AA-O-230/3a
AMENDMENT-1
April 16, 1975

FEDERAL SPECIFICATION

OFFICE FURNITURE: COSTUMER, EXECUTIVE TYPE, WOOD, TRADITIONAL, (DETAIL SPECIFICATION)

This amendment, which forms a part of Federal Specification AA-O-230/3a dated October 7, 1964, was approved by the Commissioner, Federal Supply Service, General Services Administration, for the use of all Federal agencies.

Fig. 3(2a)

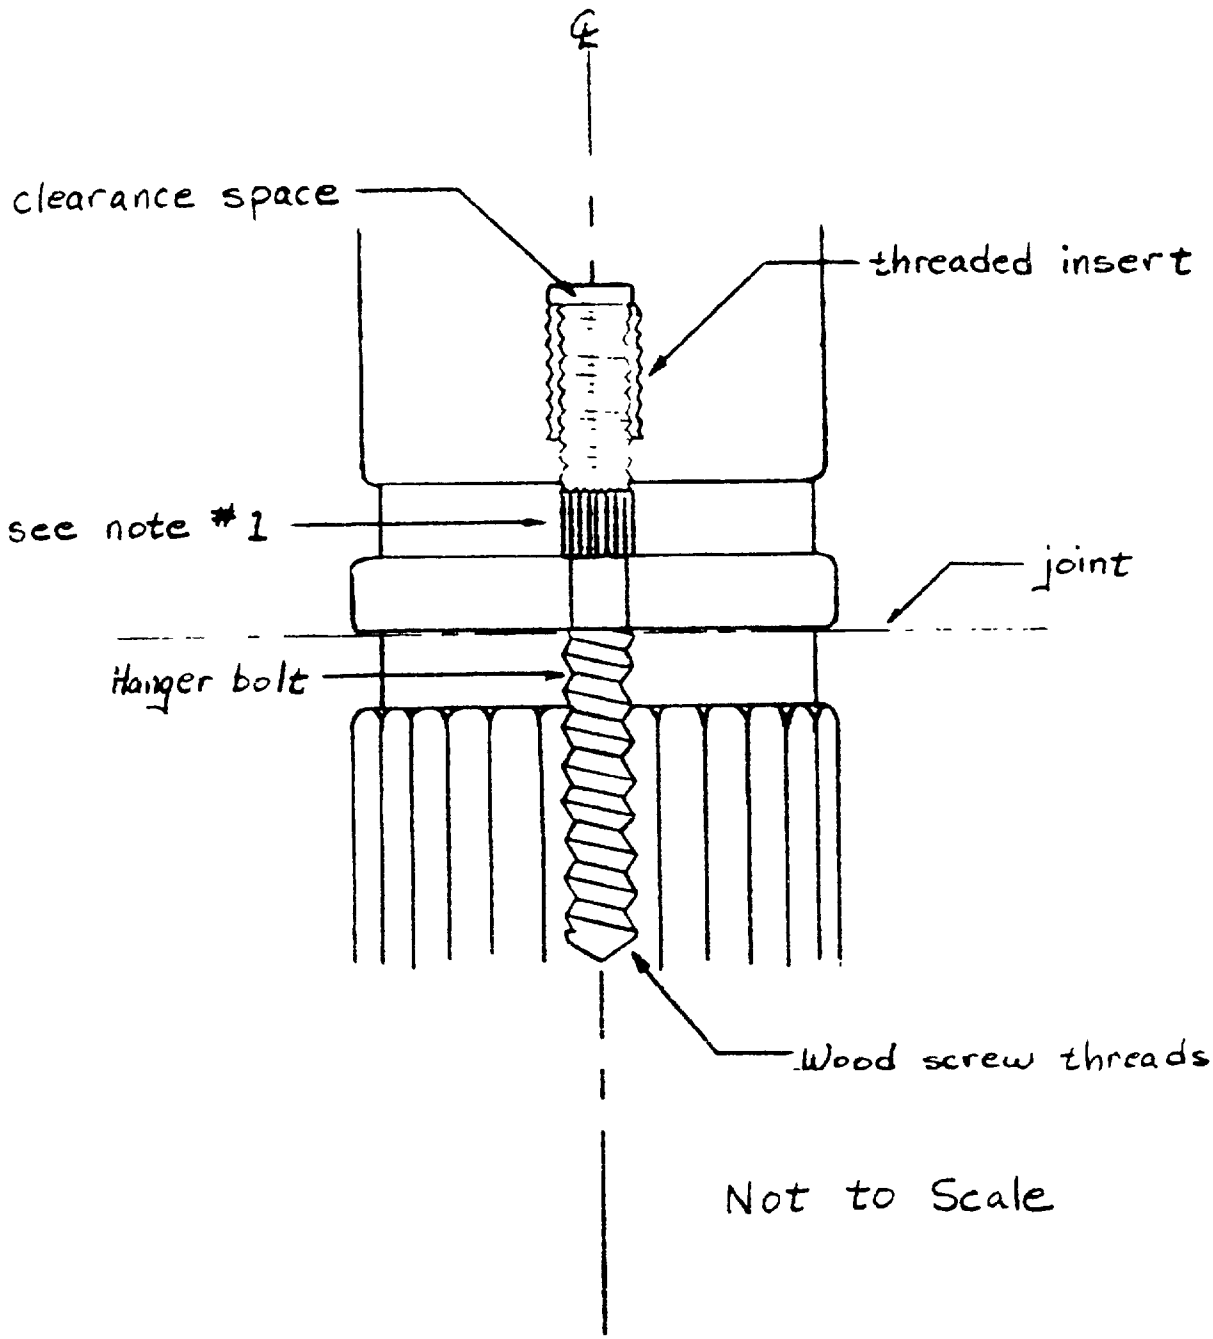
3.3.5, delete the firest sentence and substitute the following: "The shaft shall be made up of two parts, joined at the middle with a minimum 9/32 x 3-1/2 inch hanger bolt and minimum 3/4 inch long internal and external threaded inserted as shown in figure 3(2a). Both parts shall be made either of solid or built-up stock which shall be carefully matched with other parts of the costumer for color and wood grain pattern."
